STARS-10003

**STRATEGIC TEAMING AND RESOURCE SHARING (STARS)  
COMMENTS ON DRAFT REGULATORY GUIDE DG-1242,  
“SERVICE LEVEL I, II, AND III PROTECTIVE COATINGS  
APPLIED TO NUCLEAR POWER PLANTS”  
NRC Docket ID NRC-2010-0097**

Reference: 75 FR 11574, Notice of Issuance and Availability of Draft  
Regulatory Guide, DG-1242, dated March 11, 2010

Figure 1. ASTM Standards Relevant to NNP Class I, II, and III Protective Coatings

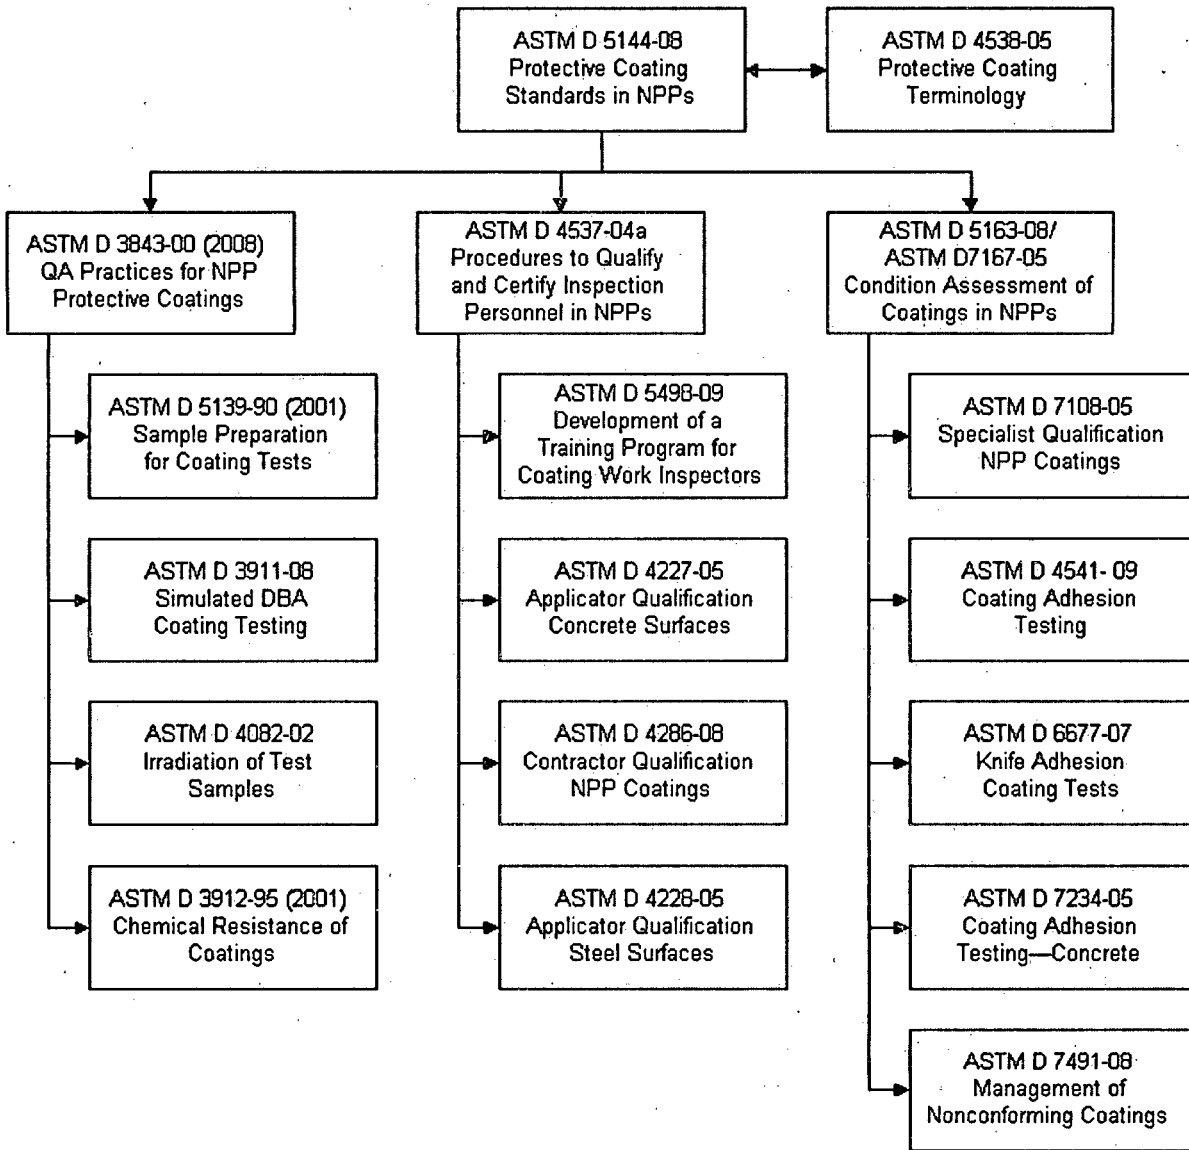
The following issues with ASTM International (ASTM) standards potentially impact Figure 1:

1. ASTM D3912-01 is used as a coating screening/qualification standard, not as a field coating assessment standard or tool. Also see Comment 4.
2. ASTM D7108-05 is used as to qualify nuclear coating specialist for the coating program and coating assessment, not coating inspections.
3. ASTM D7491-08 is part of the coating condition assessment program.
4. ASTM D3911-03 has been revised to D3911-08. Also see Comment 6.

Usage of ASTM D3912-95 (Reapproved 2001) is not consistent with Figure 1, which uses ASTM D3912-01.

Recommend incorporating all of these issues into Figure 1, which results in the following:
